CONSTRUCTION PLANS
FOR
SKYLINE AT LORSON RANCH FILING NO. 1
STORM SEWER
CONSTRUCTION PLANS
including STREETS (FOR INFORMATION ONLY)

SKYLINE AT LORSON RANCH FIL. NO. 1
STORM SEWER
CONSTRUCTION PLANS

DATE: NOV 30, 2020
PROJECT NO. 100.063
SHEET NUMBER C0.1
TOTAL SHEETS: 18

**STORM SEWER LATERAL 'B'
 STORM LATERAL 'B'
 AND POND C4 FOREBAY**

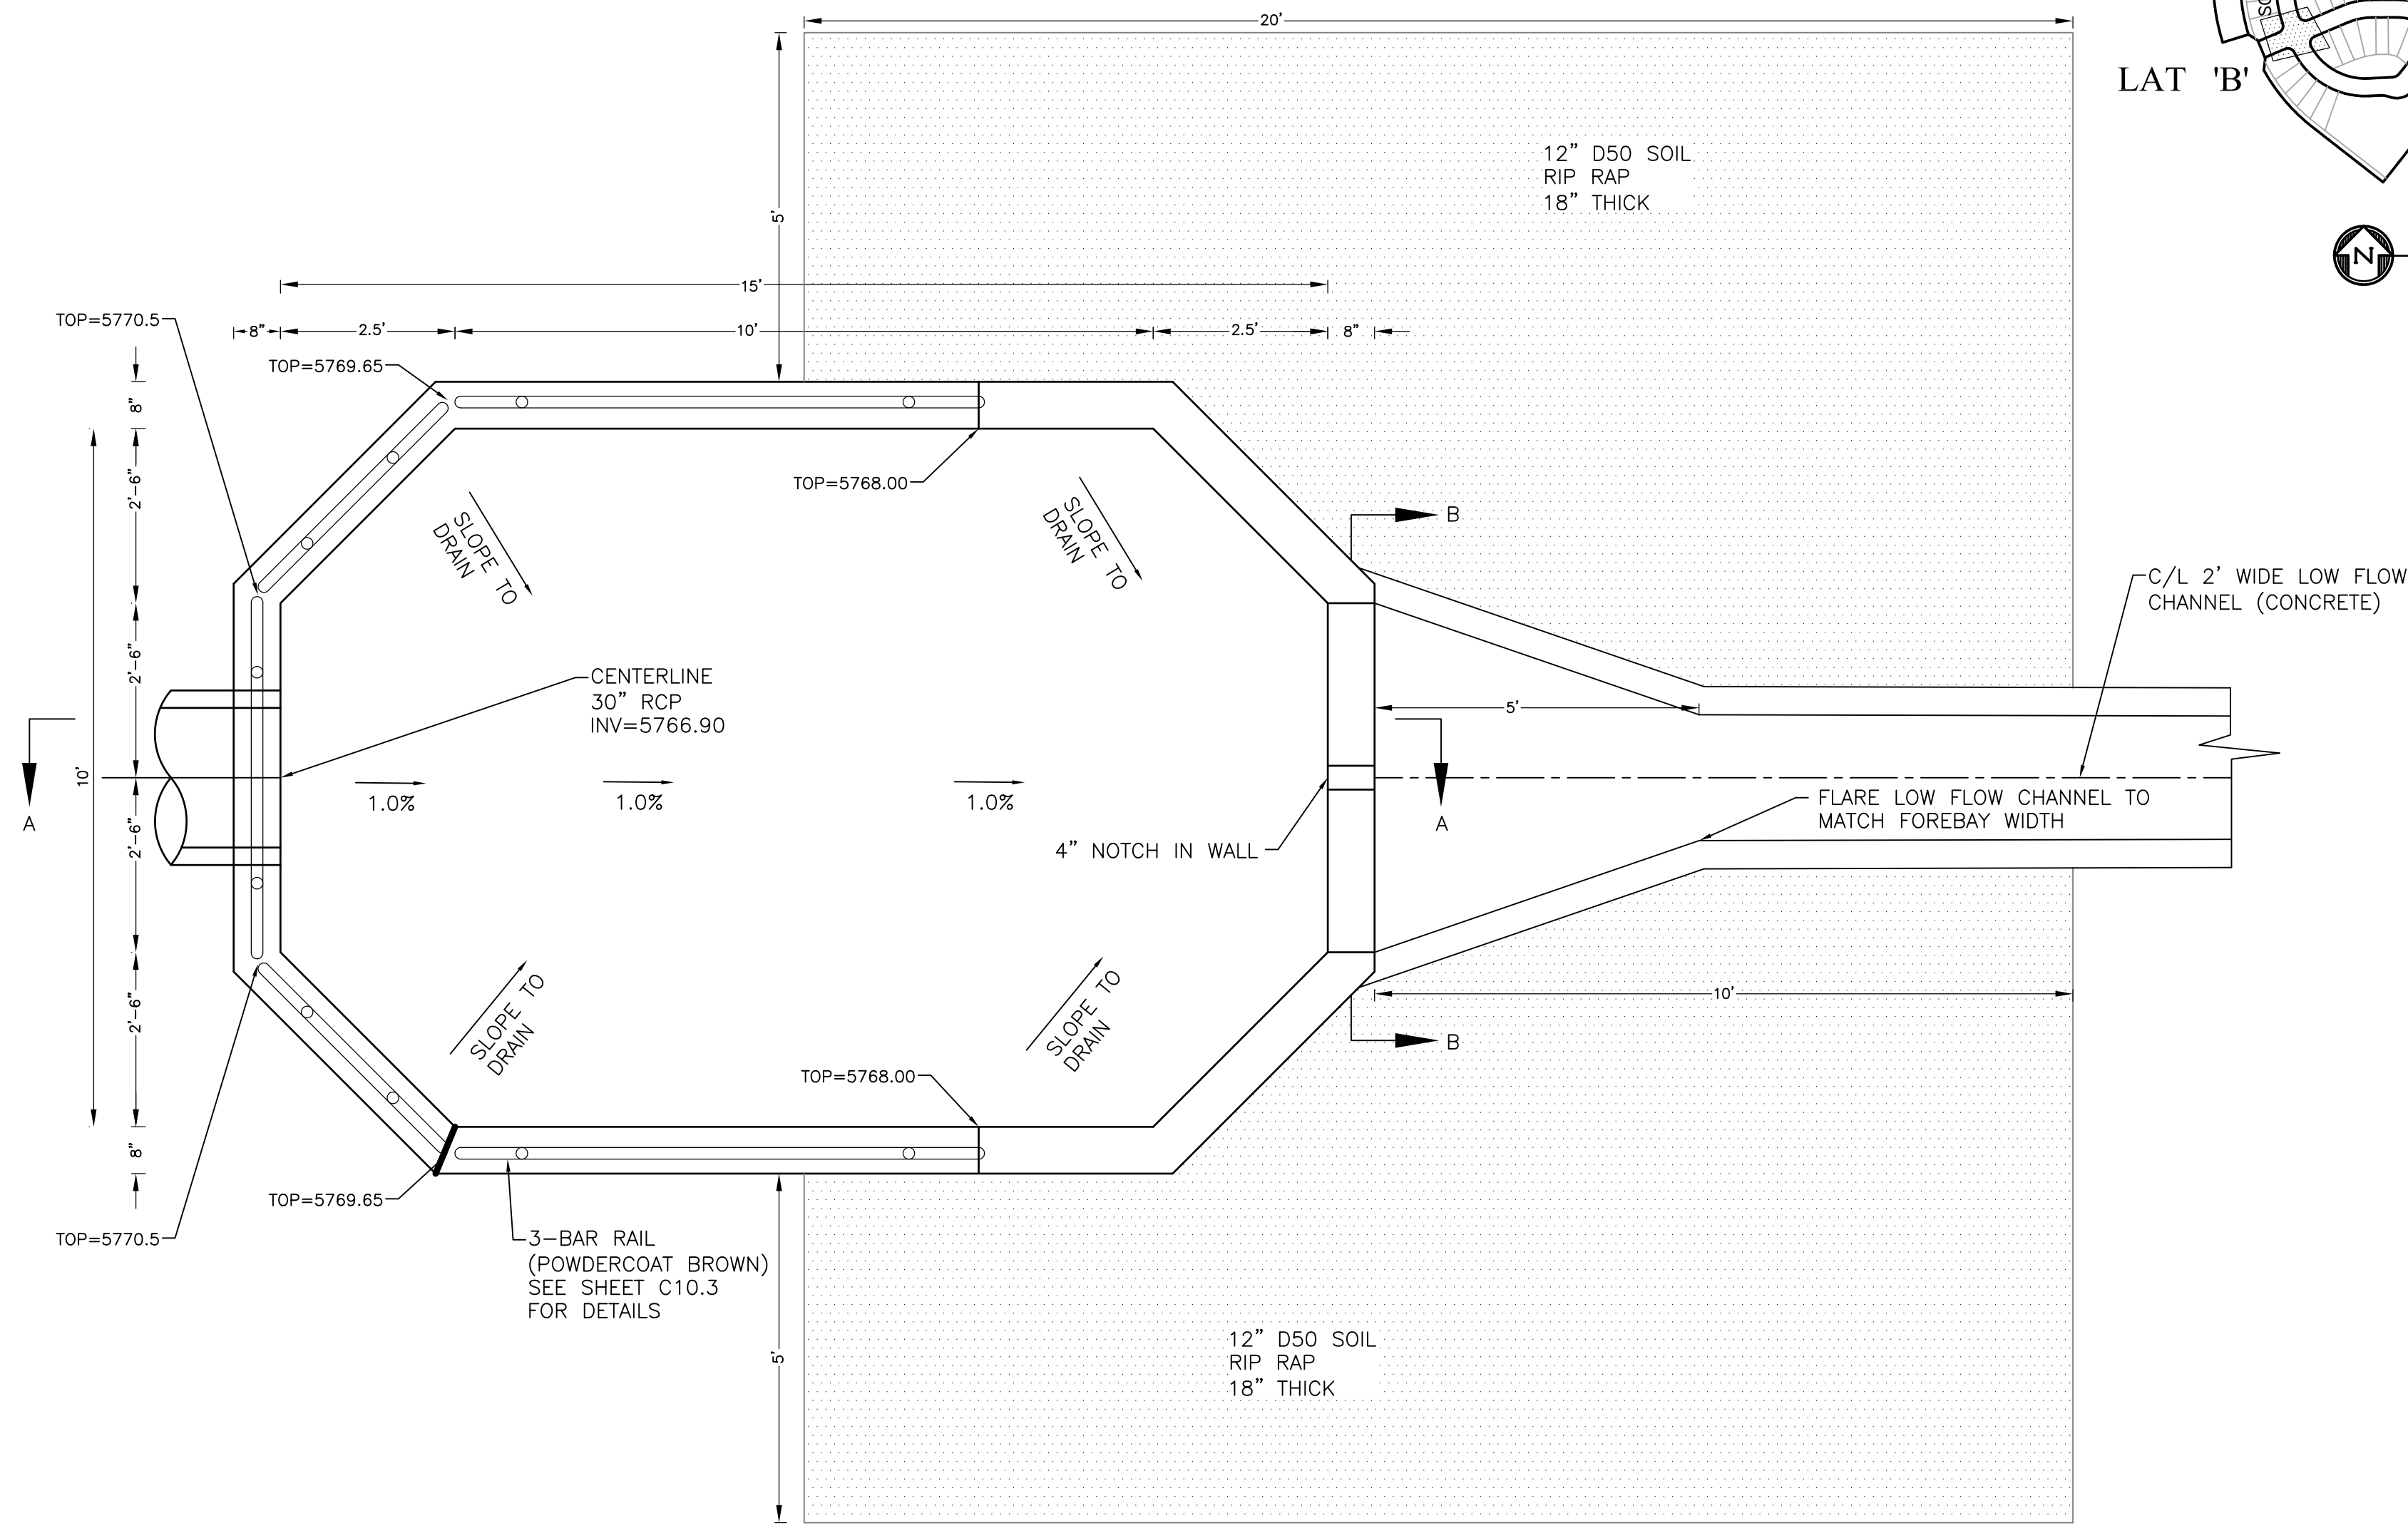
Verify that the inlets aren't too close to the ped ramps with depressions...
